# Access Compliance Report

## Public Rights-of-Way

### (Curb Ramps)

Intersection ID: 20929	Main Street: BASS_LN	Cross Street: KELFORD_LN	Location: S
ADA ID: 26C529742BA9	Ramp Type: PerpDiag	Initial Pass/Fail: Fail	Overall Compliance: No
Severity Score: 37.5			
Codes/Mitigation Info/Possible Solution		Field Measurements/Component Compliance

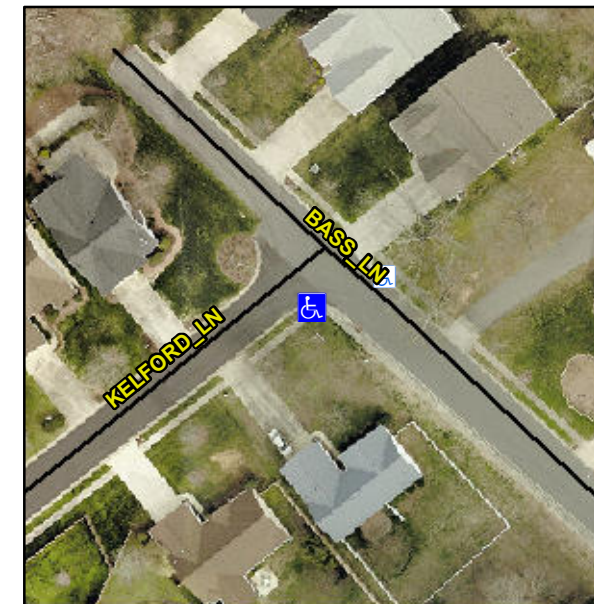
**Not Found, R304.2.2, R304.5.3**

Compliance	Description	Data	Compliance	Description	Data
N/A	Ramp Length (in)	42.0	No	Ramp Slope (%)	11.1
Yes	Ramp Width (in)	48.0	No	Ramp XSlope (%)	8.8
N/A	Flare Type LT	N/A	N/A	Flare Type RT	N/A
N/A	Flare Slope LT (%)	N/A	N/A	Flare Slope RT (%)	N/A
N/A	Flare Traversable LT?	N/A	N/A	Flare Traversable RT?	N/A
N/A	Landing Length (in)	N/A	N/A	DWS Provided?	N/A
N/A	Landing Width (in)	N/A	N/A	DWS Contrast?	N/A
N/A	Landing Slope (%)	N/A	N/A	DWS Length (in)	N/A
N/A	Landing X Slope (%)	N/A	N/A	DWS Full Width?	N/A
N/A	Landing Curb? (Y/N)	N/A	N/A	DWS Offset (in)	N/A
N/A	Shared Landing?	N/A			
N/A	Gutter Ponding?	N/A	N/A	Gutter Slope (%)	N/A
N/A	Gutter Lip Ht (in)	N/A	N/A	Gutter X Slope (%)	N/A
N/A	Painted X Walk1?	No	N/A	Painted X Walk2?	No
	X Walk 1 Direction	To E		X Walk 2 Direction	To NW
N/A	X Walk 1 Width (in)	N/A	N/A	X Walk 2 Width (in)	N/A
	X Walk 1 Slope (%)	4.0		X Walk 2 Slope (%)	5.8
	X Walk 1 X Slope (%)	4.5		X Walk 2 X Slope (%)	5.2

**Remove & Replace Curb Ramp With Two New Directional Ramps or Equivalent.**
